AGENDA
Planning and Zoning Commission
March 20, 2024 – REGULAR MEETING

Meeting Date:	March 20, 2024	Meeting Title:	Planning Commission
Submitting Department:	Planning Department	Presenter:	Katelyn Page
Agenda Item:	Sketch Plan for 3-story hotel at 210 and 230 N. Glenwood Street (P24-018)	Public Comment:	Yes

Permit # P24-018 Parcel # : 22-41-16-28-4-07-011
Site Address: 210 N GLENWOOD STREET
Project Name: 210, 230 N. Glenwood - Glenwood Hotel - Sketch Plan

A1.00

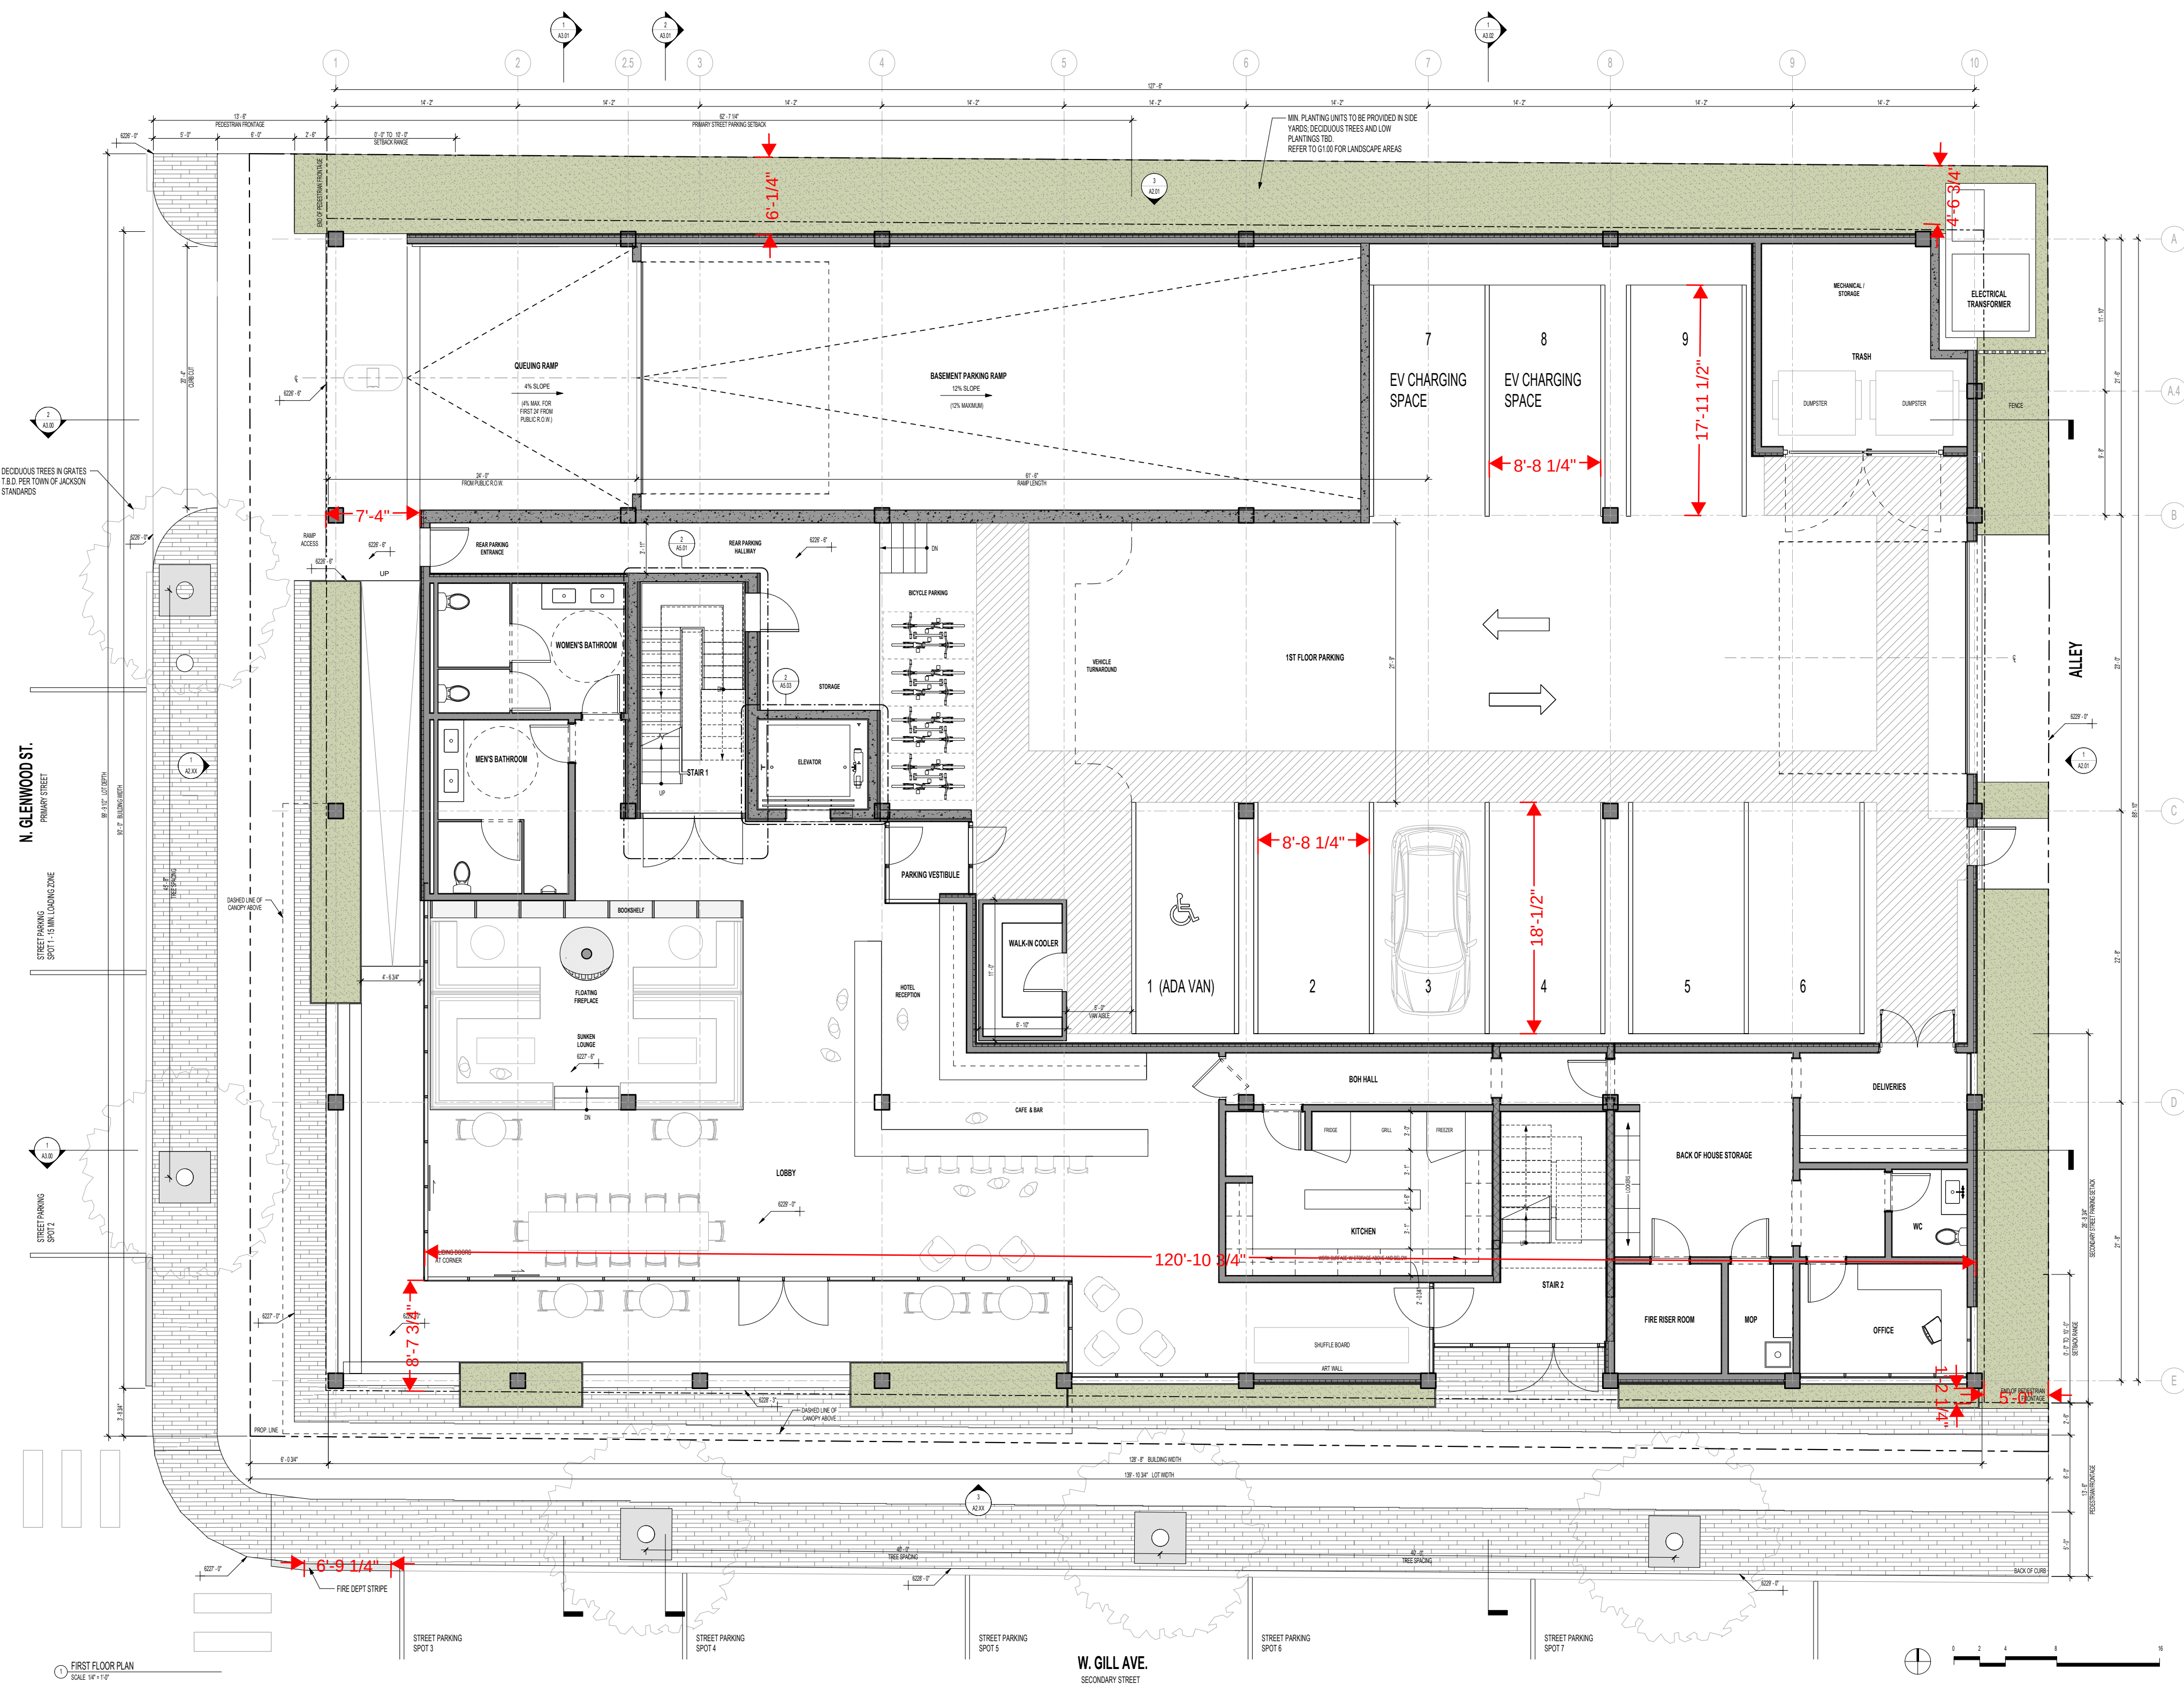
10. **Designated 15min On-street space** - Review of designated “guest check in” on-street vehicle parking space. Include a detail of this request within your sketch plan and development plan submittals. Include number of requested spaces, location of spaces along Glenwood or Gill, and suggested timeline for stall turnover such as 15min. Staff will present this to Council alongside your sketch/development plan requests.

- As shown on plan A1.00 & A1.01, one street parking spot on Glenwood has been designated to be a 15 min loading spot.

1 THIRD FLOOR PLAN
SCALE 1/4" = 1'-0"

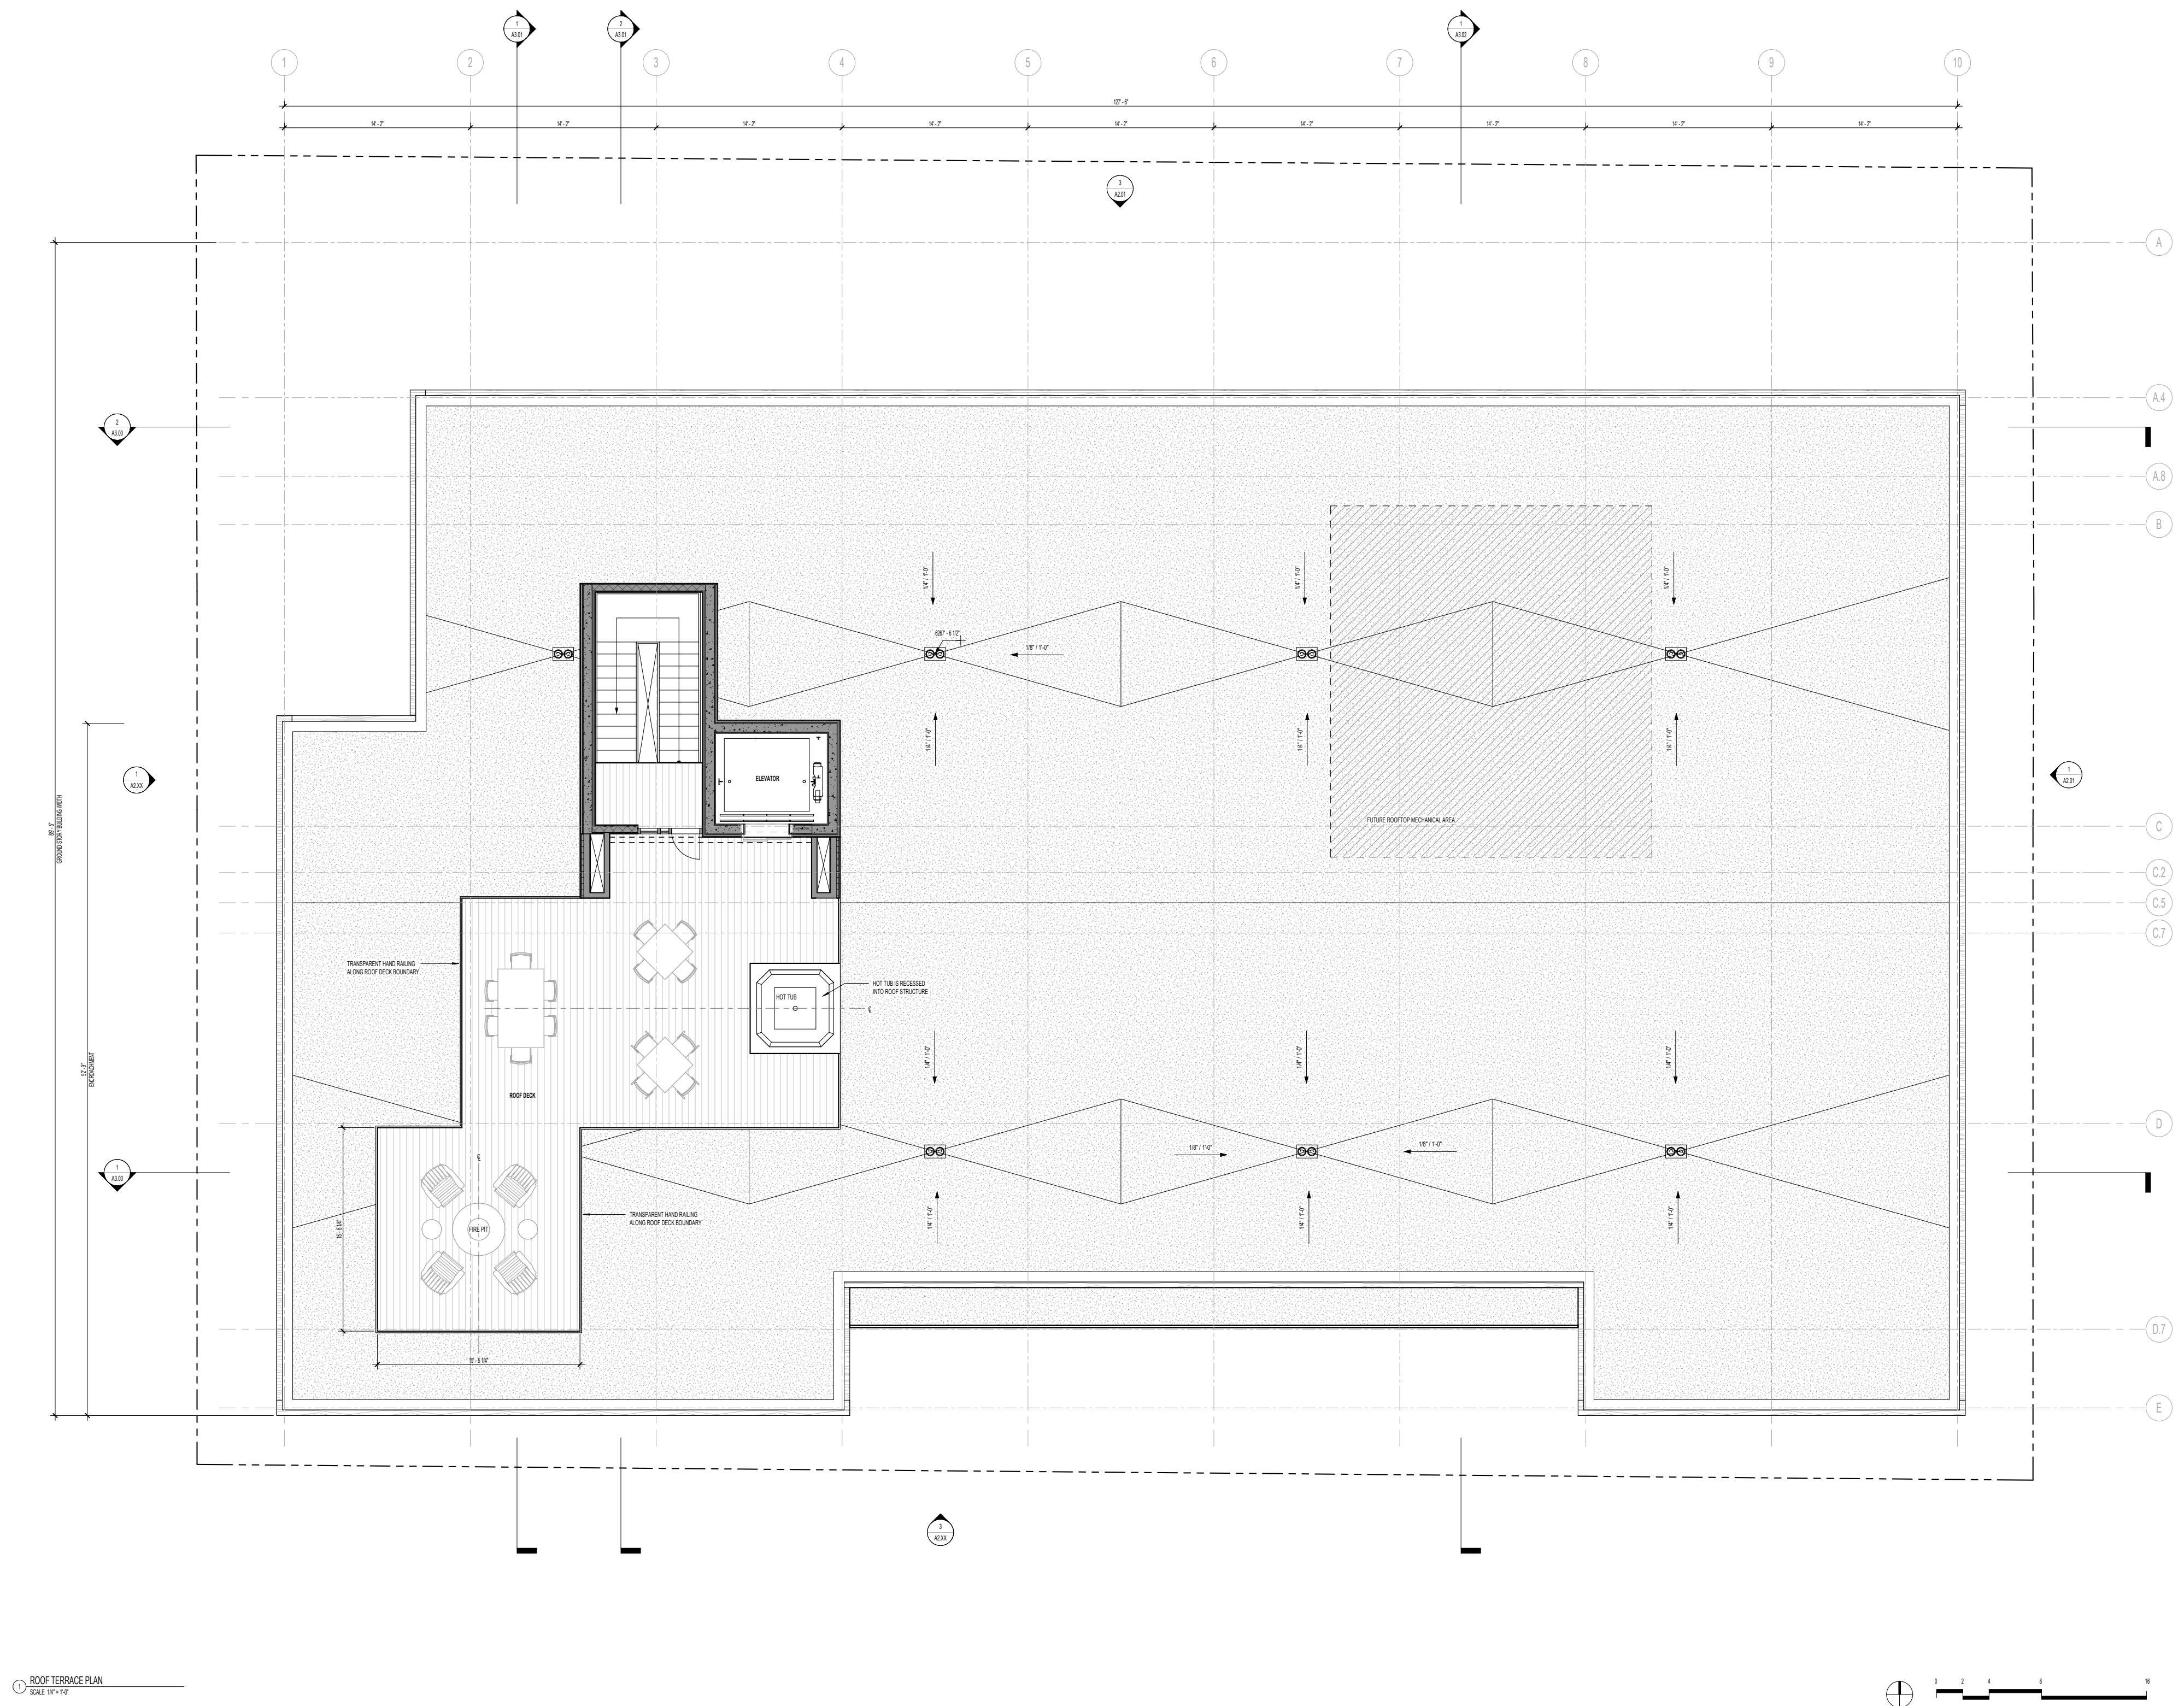
- Housing Mitigation Plan is included in the application.
5. **3rd Story setback and encroachments into** – Planning Director confirmed the design as currently shown does not meet required 10’ setback at 3rd floor or 3’ allowed encroachment into said setback (northwest corner). Additionally, it is not the purview of the DRC committee to address, review, or approve LDR compliance as their review is limited to the Town’s Design Guidelines. Revise design prior to DRC and Sketch Plan submittal. See LDR Sec. 9.4.1 for rules of measurement pertaining to setback.

- As shown on plans A1.03, A1.50, A1.51 and A2.00, the structure has been revised to meet the 3rd floor setback requirements.
6. **Roof top mechanical room** - The proposed rooftop mechanical room exceeds allowed building height and is not included in height allowance for elements used exclusively for elevator or stairway access to a roof. Revise design prior to DRC and Sketch Plan submittal.
